# GRADING AND EROSION CONTROL PLANS FOR WALDEN SANITATION DISTRICT WASTEWATER TREATMENT PLANT PROJECT EL PASO COUNTY, COLORADO MARCH 2026

PCD PROJ. NO. : PPR2538

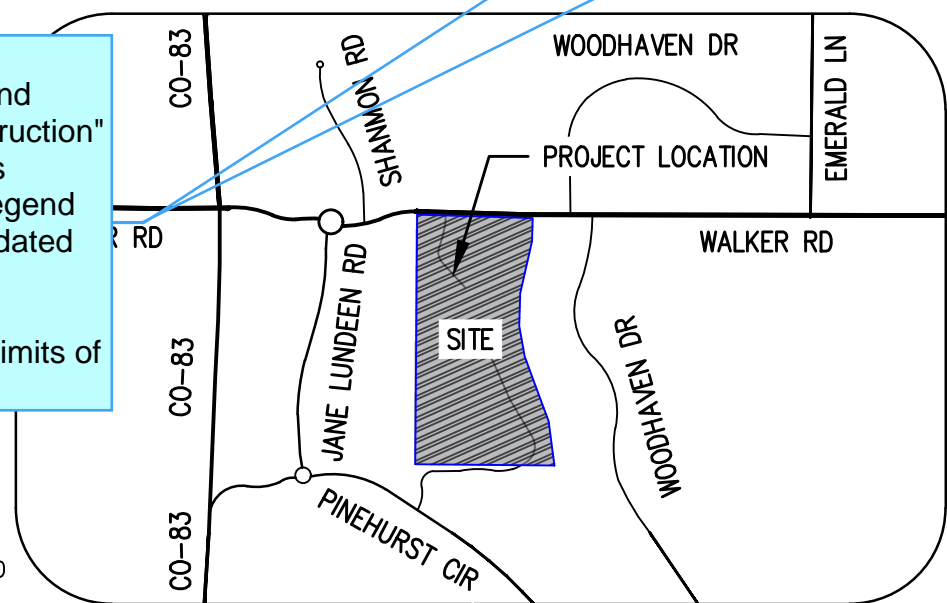
EPC DPW Stormwater did not fully review the last GEC submission since it was not associated with a stormwater permit. New information provided with this submission has triggered the requirement for an ESQCP, so full comments will be provided at this time. See comment on sheet 12 for additional information.

If "limits of disturbance" and "construction boundary" are the same, change to "limits of construction/disturbance" or otherwise show as separate line types for each on the legend and figure.

"Limits of disturbance" and "limits of construction" were shown as separate, on legend and figure. Updated the name from "disturbance boundary" to "limits of disturbance"

SHEET TITLE:  
 EROSION CONTROL PLAN I  
 PROJECT NUMBER: #3774  
 SCALE: 1:100  
 SHEET: C7.1

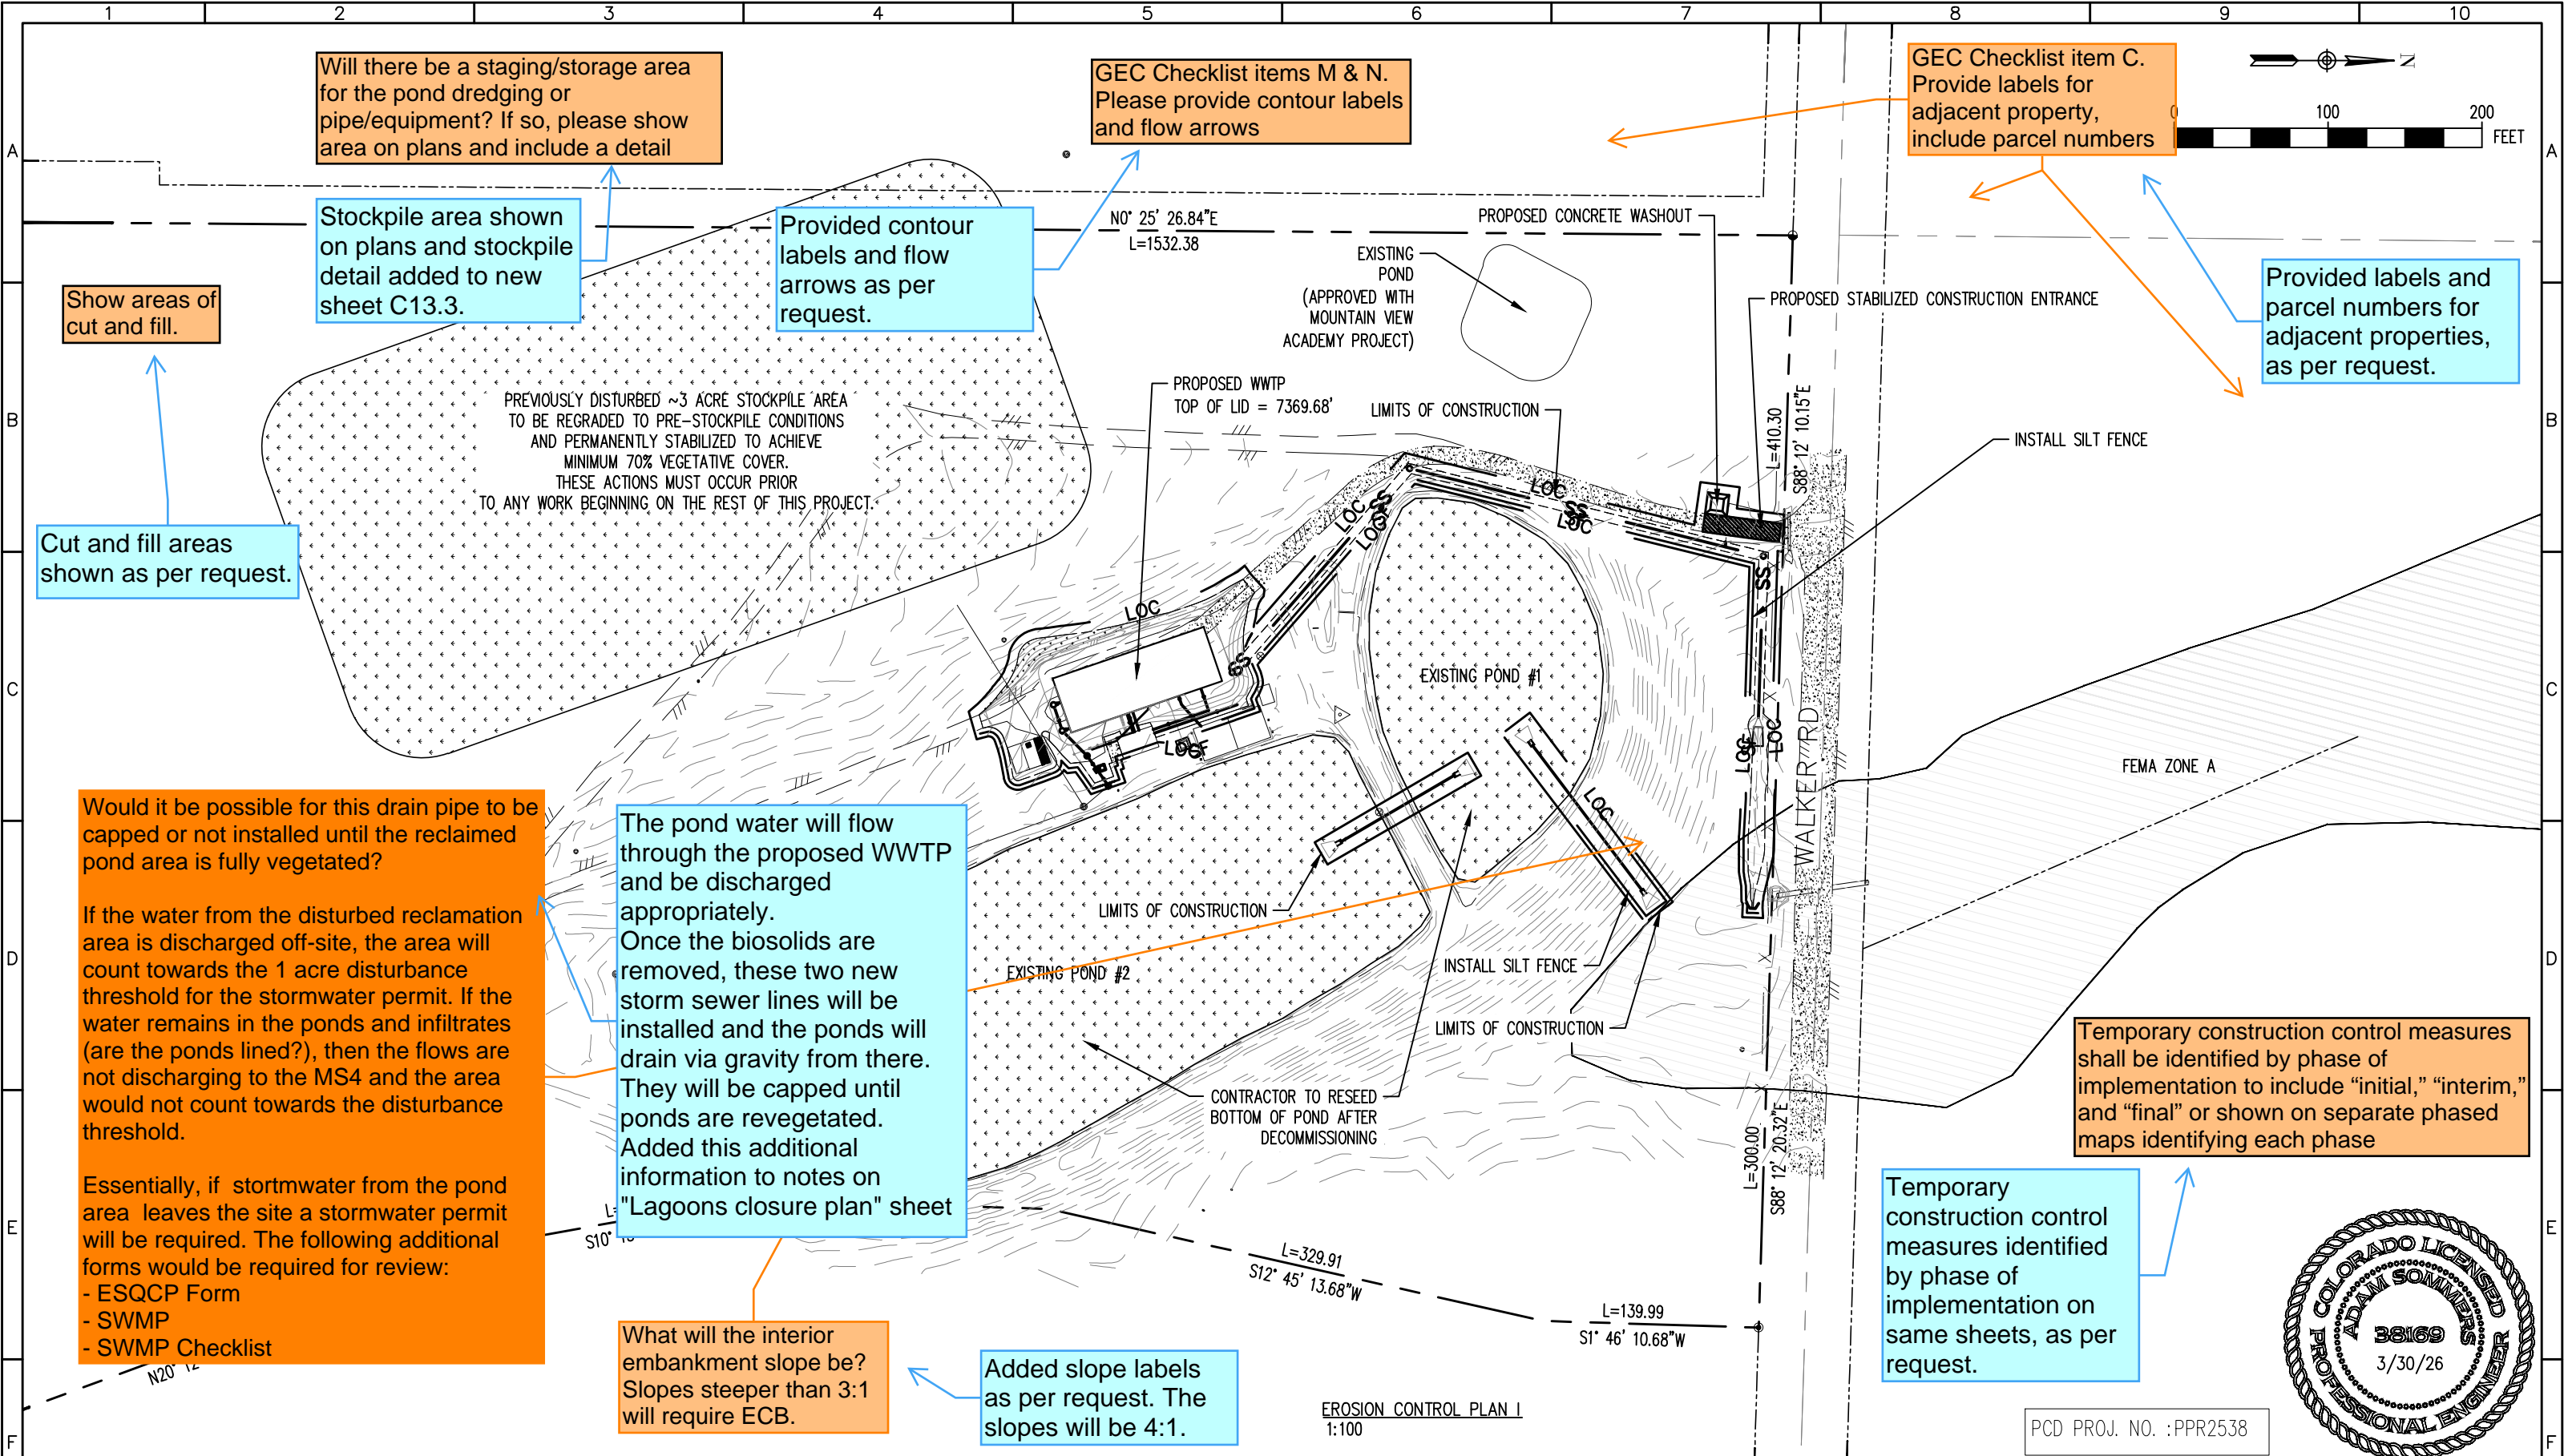
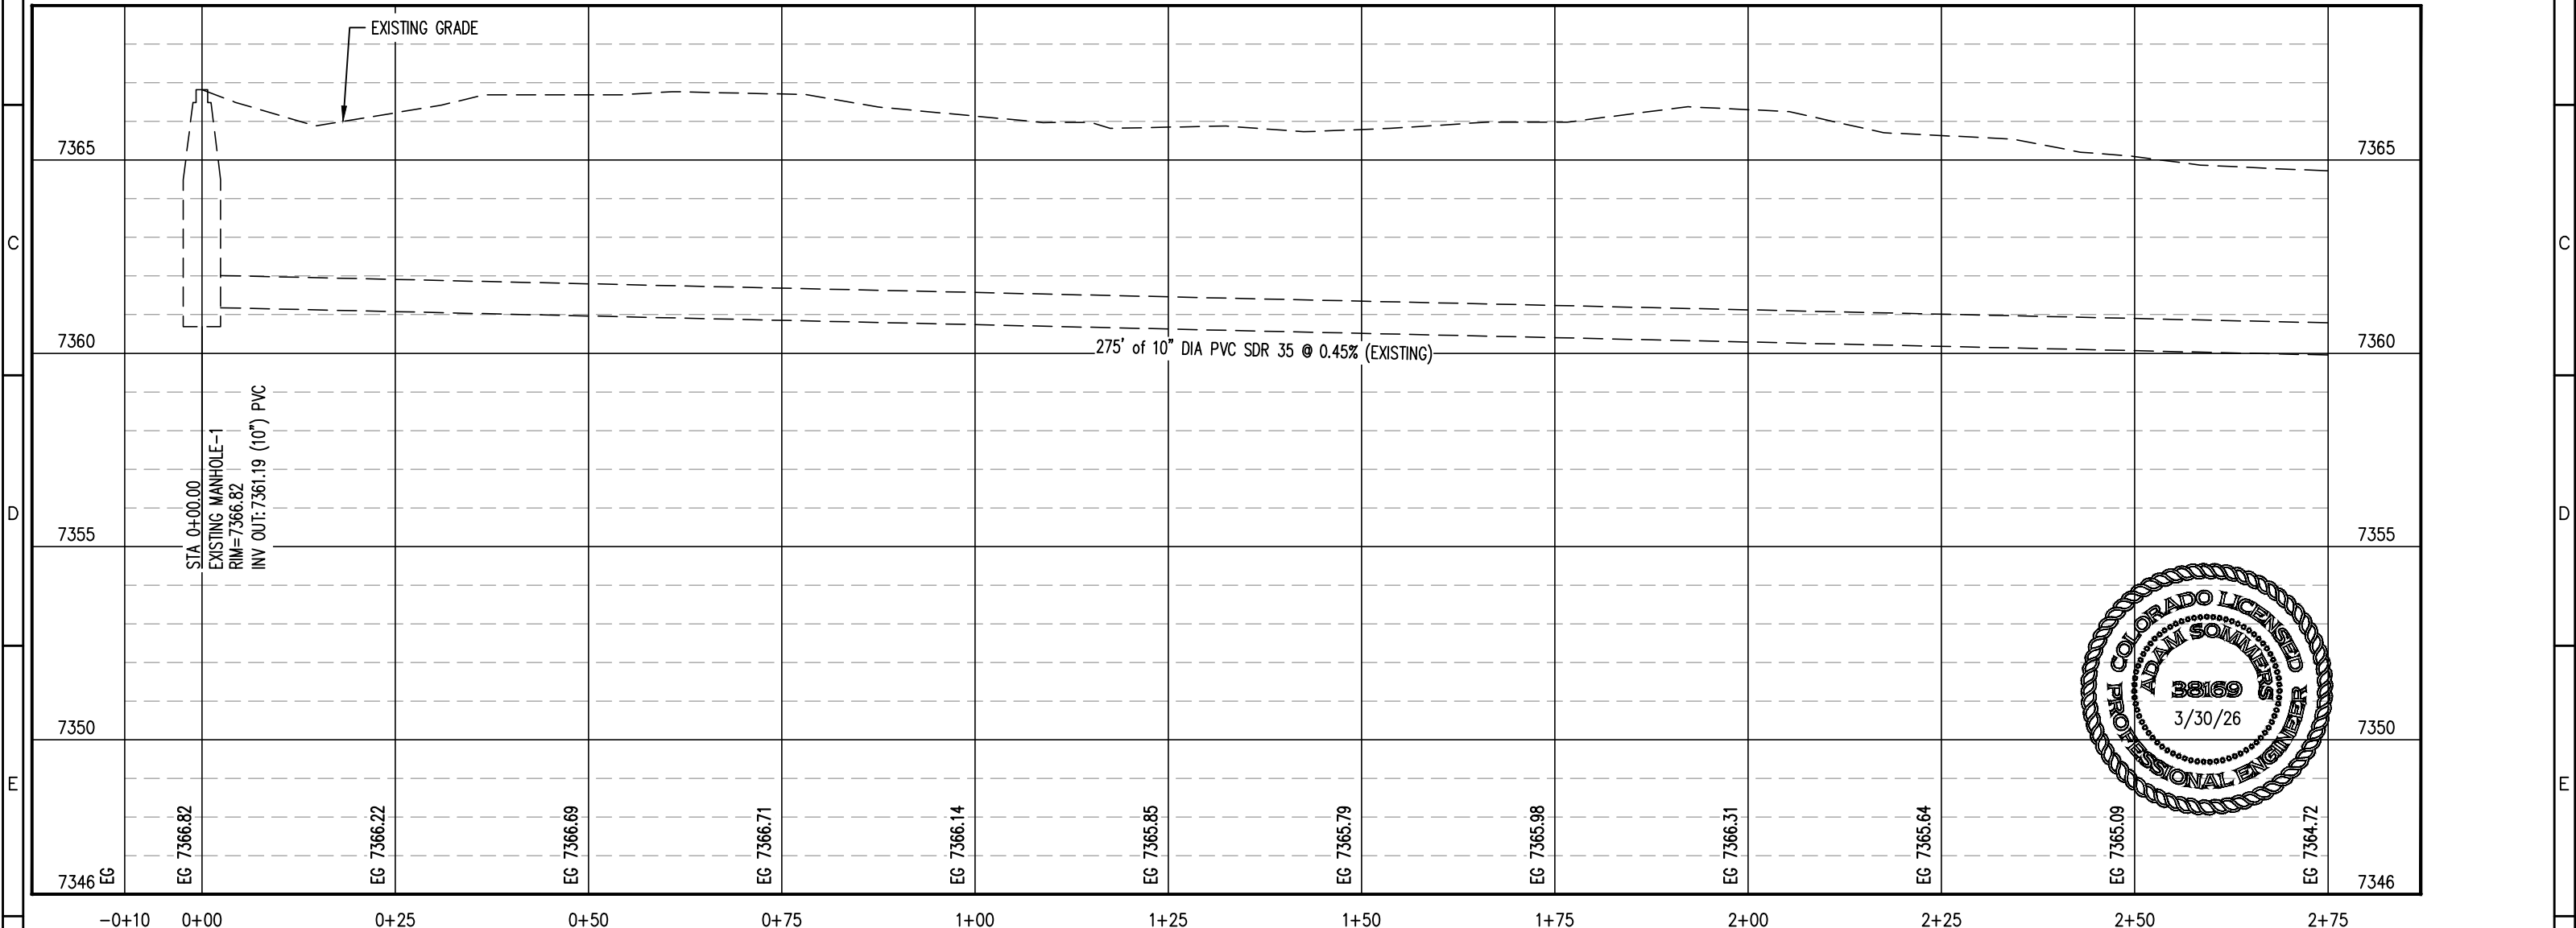
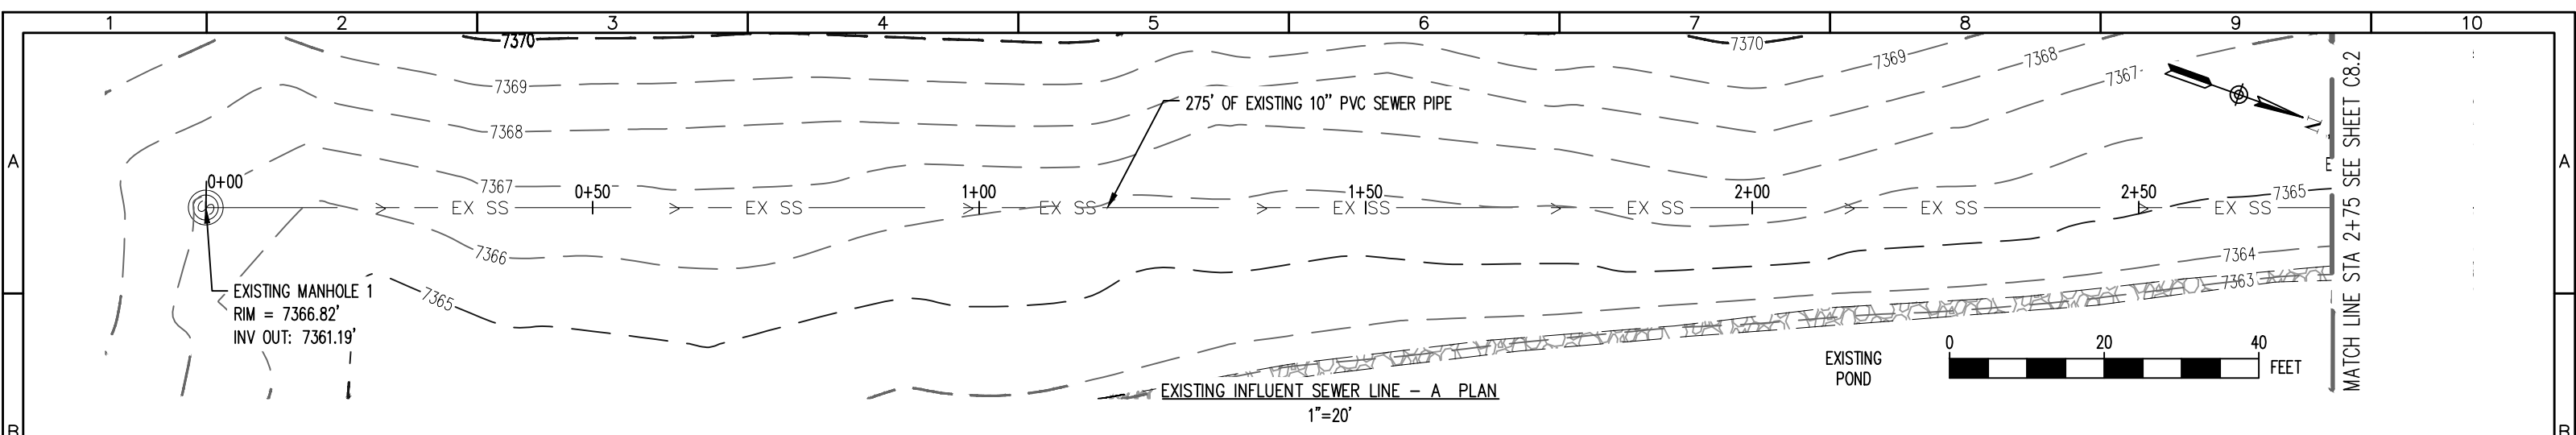
Will there be a staging/storage area for the pond dredging or pipe/equipment? If so, please show area on plans and include a detail

GEC Checklist items M & N. Please provide contour labels and flow arrows

GEC Checklist item C. Provide labels for adjacent property, include parcel numbers

Show areas of cut and fill.

Stockpile area shown on plans and stockpile detail added to new sheet C13.3.

Added slope labels as per request. The slopes will be 4:1.
